REVISED RESPONSE TO REQUEST FOR ADDITIONAL INFORMATION**APR1400 Design Certification****Korea Electric Power Corporation / Korea Hydro & Nuclear Power Co., LTD****Docket No. 52-046****RAI No.: 131-8087****SRP Section: 11.05 - Process and Effluent Radiological Monitoring Instrumentation and Sampling System****Application Section: 11.05****Date of RAI Issue: 08/07/2015****Question No. 11.05-1**

11.5 - SRP 11.5.2.2, Description of the PERMSS

Gaseous PERMSS

RAI 131-8087 - Question 11.05-1_Rev.2

Figure 11.5-2Z Location of Radiation Monitors at Plant (Turbine Generator Building El. 170'-0")

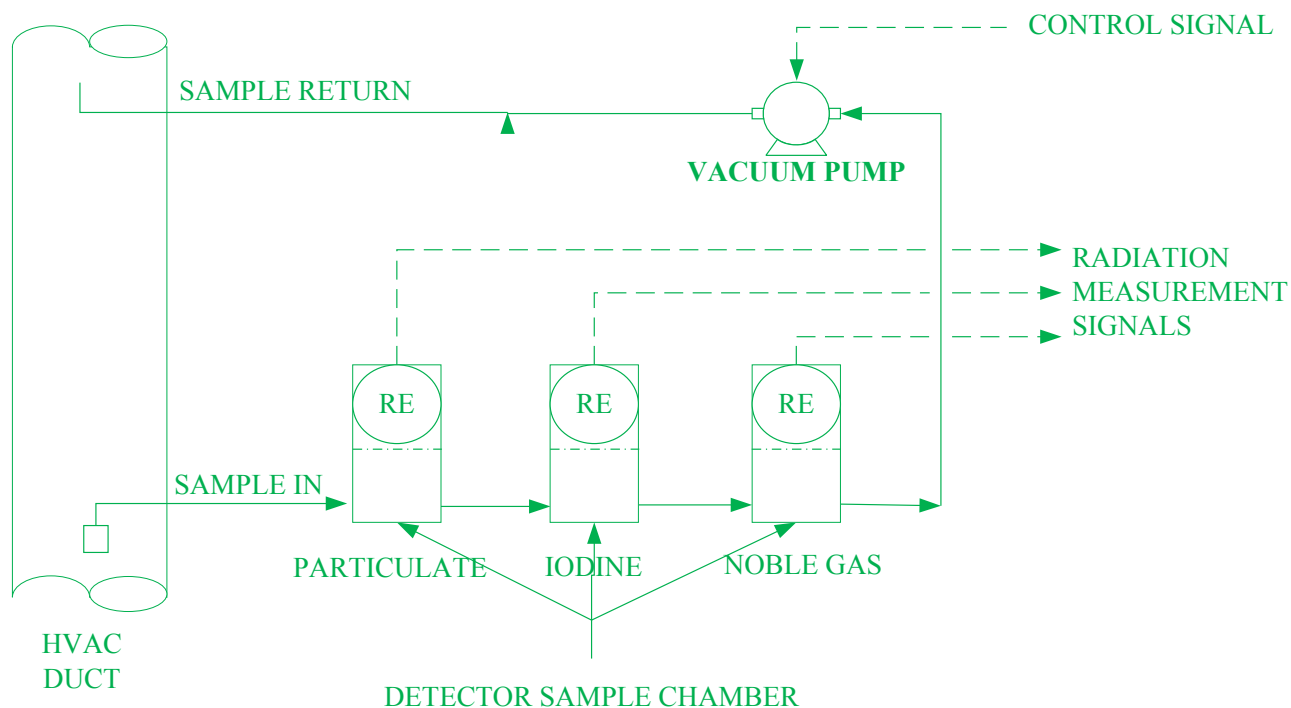
Information contained in DCD section 11.5.2.2 does not include the level of detail SRP section 11.5 describes for the description for the PERMSS. The description of monitors in DCD section 11.5.2.2 for the Gaseous PERMSS, and the detectors functions are not completely described in Table 11.5-1. There are several instances where a detector will have the function and remark of "Alarm (MCR)" but have no clarifying detail to describe these functions in DCD section 11.5.2.2. Upon inspection of Tier 1 Section 2.7.6.4 NRC staff observes that there are indications not described in Section 11.5 that are seen in Tier 1 Table 2.7.6.4-1. Tier 1 Table 2.7.6.4-1 has a column to describe any Display/Alarm at MCR/ or RSR indication. Each detector in this TIER 1 table has a "Yes" marked for all three indications, however DCD Section 11.5 does not include a full description of all indications in either the text or DCD Tables 11.5-1.

The locations of each monitor are described in Subsection 11.5.2.2 and the physical locations are shown in the Figure 11.5-2.

Figures 11.5-2 will be revised to show the correct location of the radiation detectors (RE) and the monitor electronics/displays (RT). In the figures, RE/RT means that the detector and electronic/display are installed together adjacent to each other. The location of some RE and RT have been changed to the correct location. Subsection 11.5.2.2.5 will be added to describe that the location of each monitor is shown in Figures 11.5-2.

DCD Tier 2, [Table 1.8-2](#), Subsections [11.5.1.2](#), 11.5.2.2, 11.5.2.3, 11.5.3, 11.5.4, [11.5.5](#), [11.5.6](#) and Table 11.5-1, Figures 11.5-2E, 11.5-2F, 11.5-2G, 11.5-2H, 11.5-2I, 11.5-2J, 11.5-2K, 11.5-2L, 11.5-2M, 11.5-2O, 11.5-2P, 11.5-2Q, 11.5-2U, 11.5-2V, 11.5-2W, 11.5-2Z, and 11.5-2BB will be revised.

The monitor is located in Turbine Generator Building as shown in Figure 11.5-2Z.
